Agenda
City of Springboro Planning Commission Meeting
Wednesday, January 18, 2023, 6:00 p.m.
Council Chambers, City Building, 320 West Central Avenue

Background Information Staff Comments/Recommendation
City of Springboro Planning Commission Meeting
Wednesday, January 18, 2023, 6:00 p.m.
Council Chambers, City Building, 320 West Central Avenue

Record Plan, The Ascent, Section 3, western terminus Pinnacle Point Drive, commercial plat

General Plan, Clearview Crossing at Stoneridge, southwest corner of East Central Avenue (SR 73) and Red Lion-Five Points Road, residential subdivision

RECORD PLAN THE ASCENT SECTION THREE

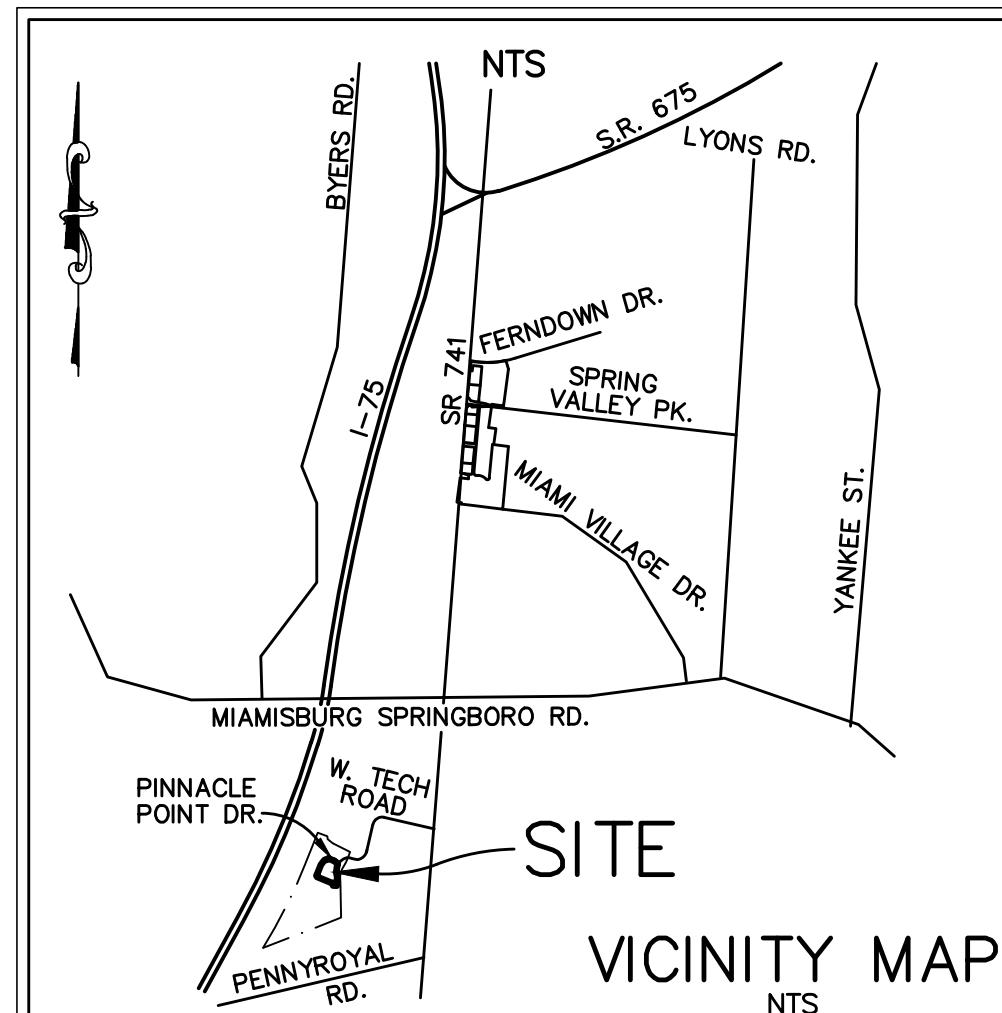
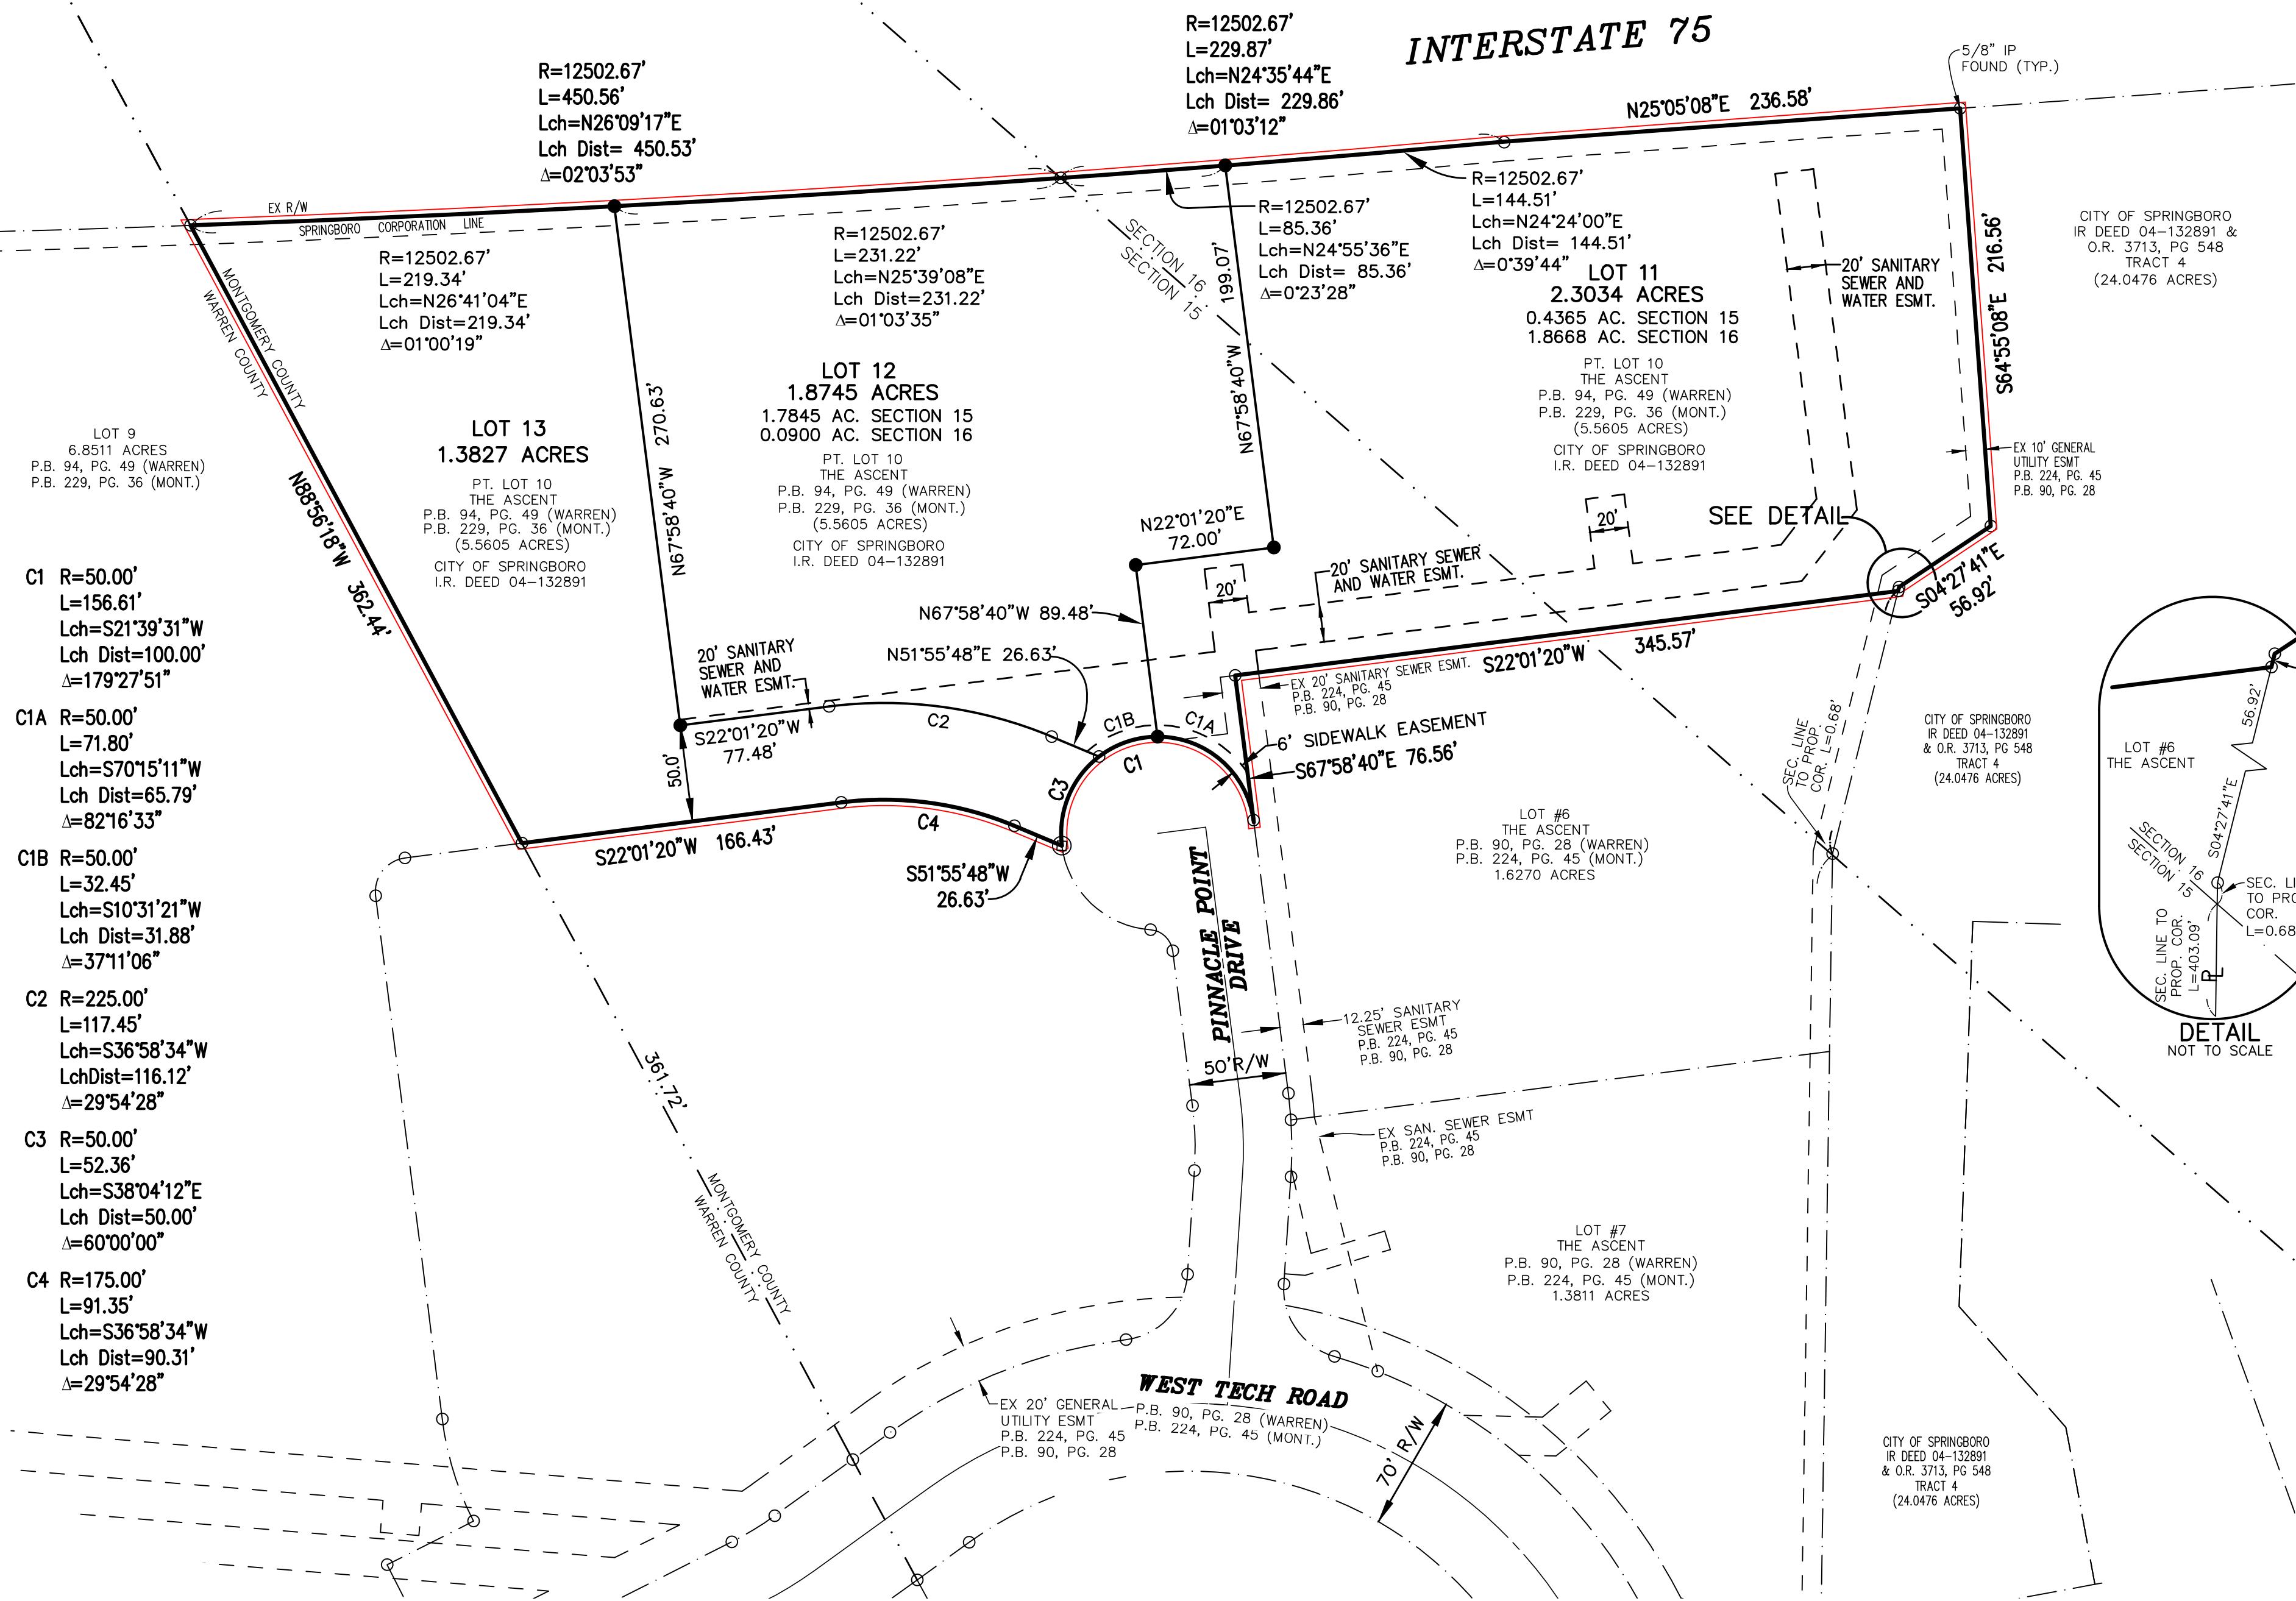
1. Provide sidewalk easement to cover the sidewalk as shown on construction drawings adjacent to Pinnacle Point Drive. Also provide a 10-foot utility easement around cul-de-sac.
2. Provide Lot 8 information.
3. Submit to Montgomery County for their review, and make revisions accordingly, if any.
4. Easements to match construction drawings.

EXHIBIT B
SIGHT DISTANCE AT HAVERSTRAW PLACE

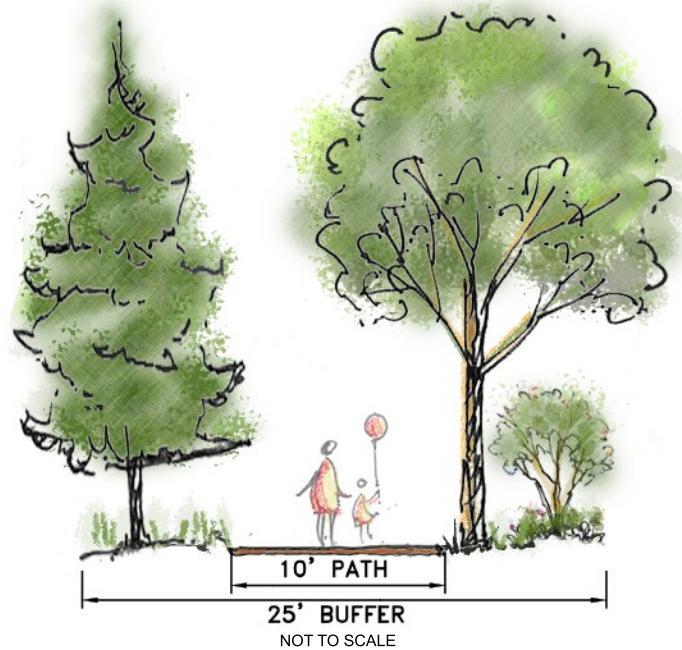
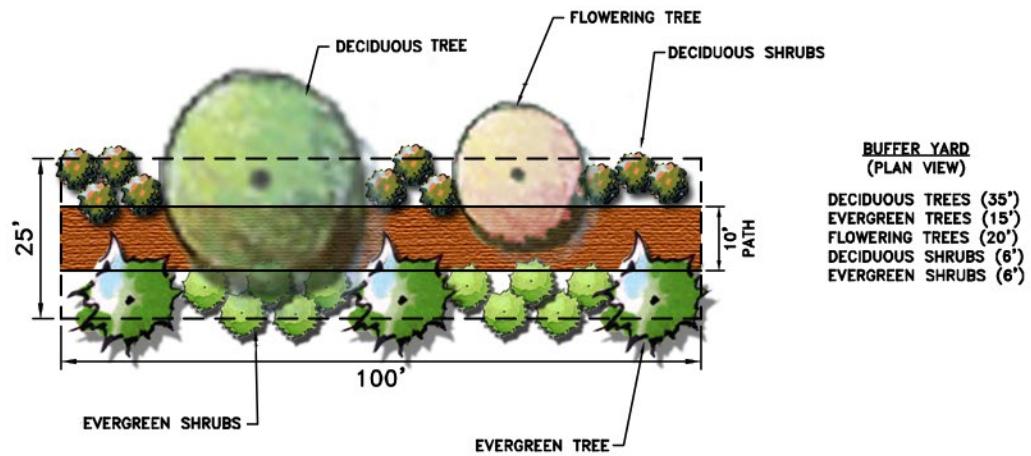
15. *Provide intersection sight distance at the west intersection with Haverstraw Place per ODOT standards. Adjust lots 15 and 23 accordingly (and setbacks) and provide sight distance easement.*

Response: West-bound vehicles will be stop controlled at the intersection to Haverstraw Place and a speed limit of 25 mph for both roads. Site distances will be about 150'. Building setbacks are shown on the Layout Plan (Refer to sheet 3 of 4). Homes would be set behind the setback line. Providing clear site lines for 150'. Right-of-way and buffer landscaping within any potential sight lines will avoid evergreen plant species. Contour lines depicted on plans reflect the existing topography of the site. Proposed contour lines, needed to confirm compliance with ODOT standard sight distance triangles, will be shown upon creation of the Grading Plan, at the final development plan submittal.
